**HM/A-19:462 (2782 Barton St. E., Hamilton)**

Consolidation Report

**HM/A-19:462 (2782 Barton St. E., Hamilton)**

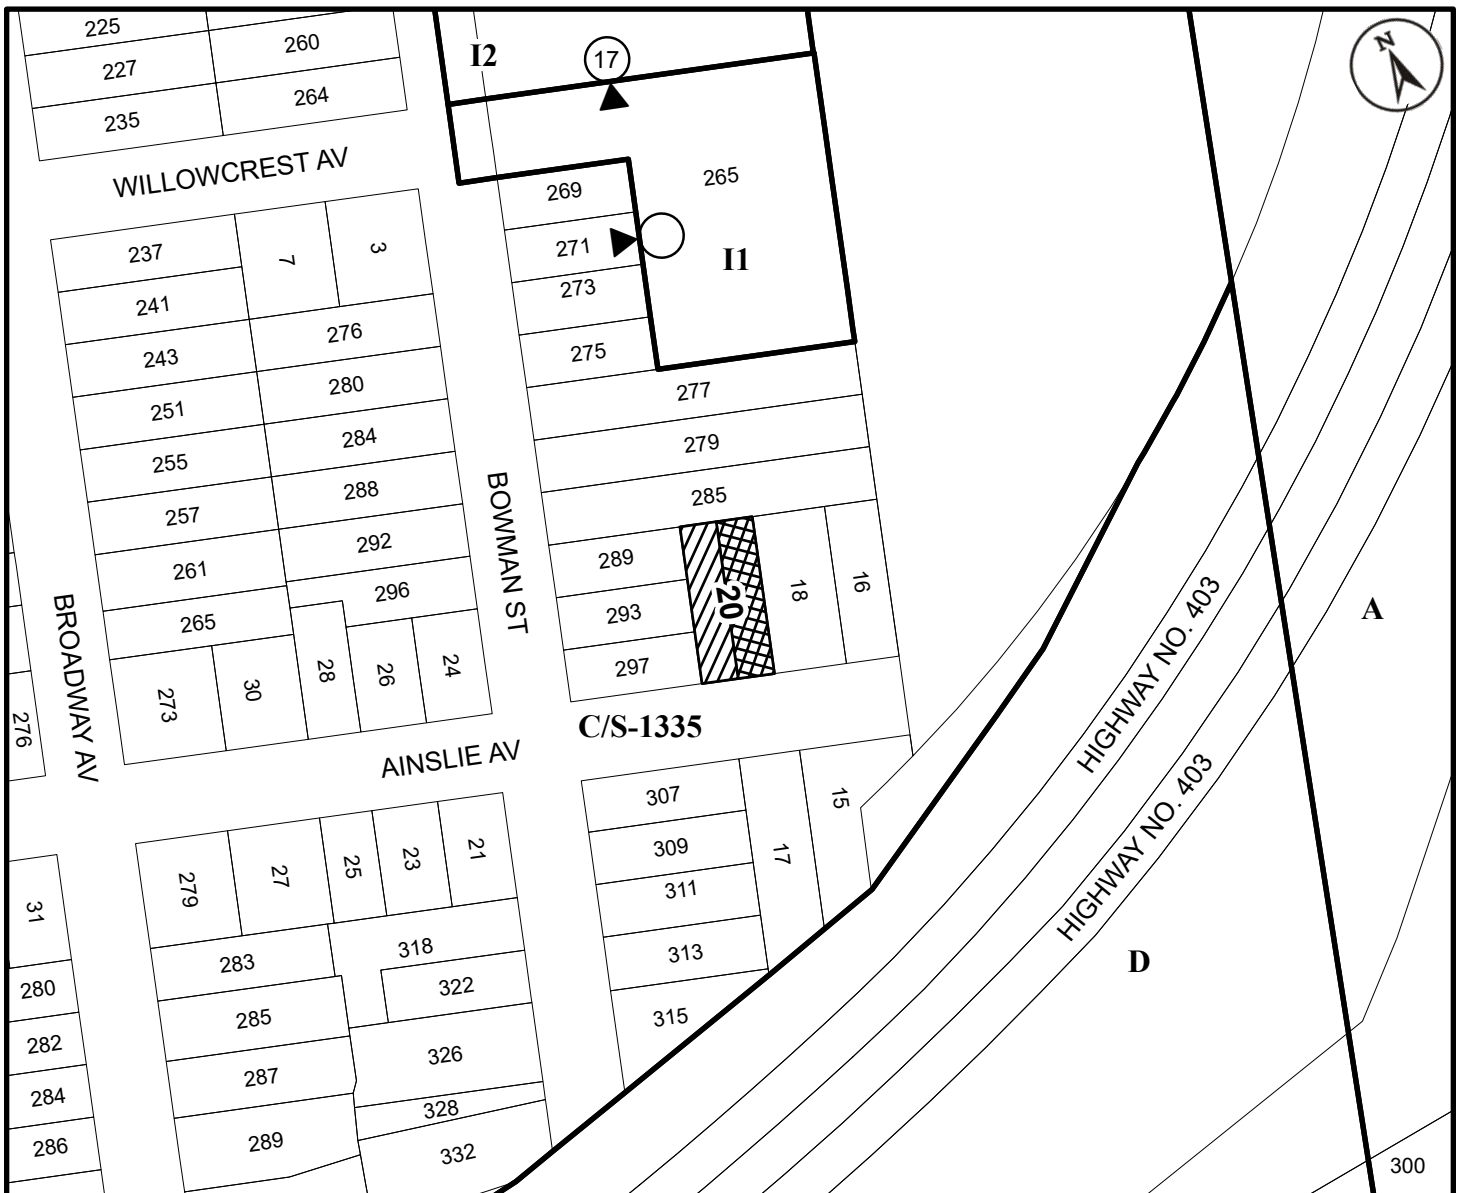
1: No: 18 is stated as one storey on the plot. No. 18 is 1 ½ stories, with a window upstairs that would look out to a brick wall.

2: On No. 18 plot – porch is listed as covered – my understanding of “covered porch” would mean that it had a roof of some sort – it does not.

3. On the original version of what actually there – Cedar hedge etc. are all drawn in. In the version of what is envisioned for the new buildings – all that is mentioned is "cedar hedge", no drawings of said hedge and from my estimation there would not be any room for a hedge at the side of the new house.

4. One nice Japanese Maple tree would be cut down, along with presumably most or all of the cedars at the side of the house.

Garage  
988 Concession St  
West Elevation

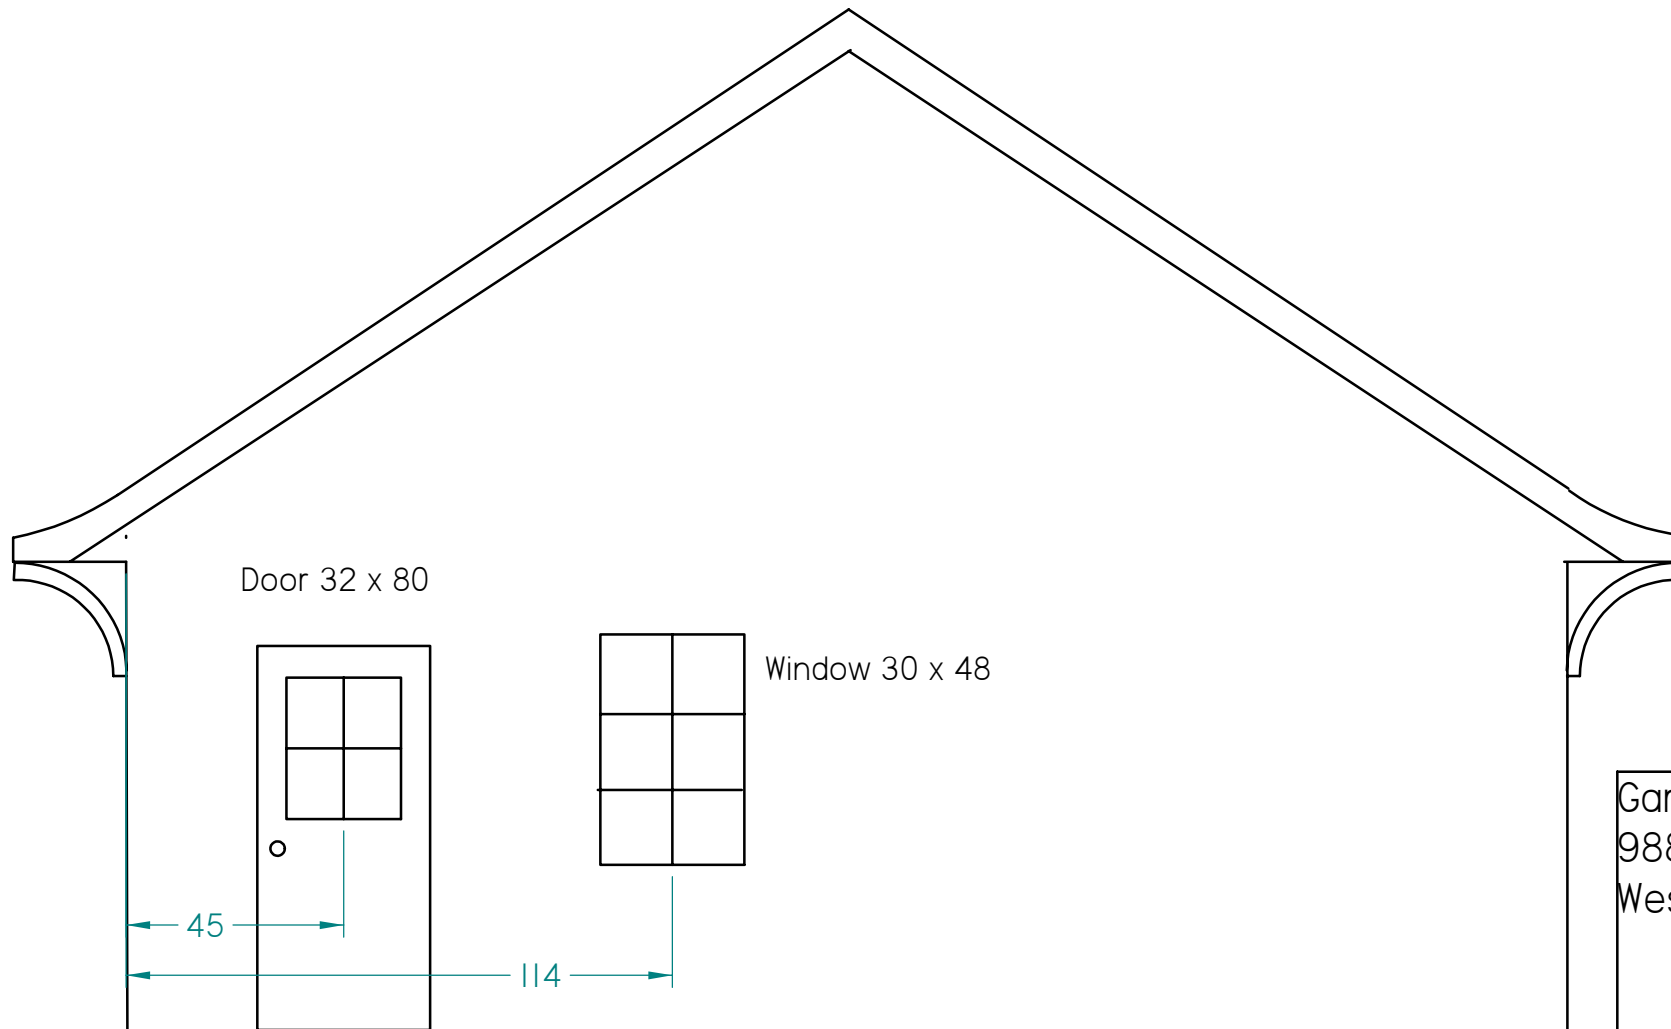
GARAGE WITH 8/12 ROOF PITCH - HEIGHT 5.4m
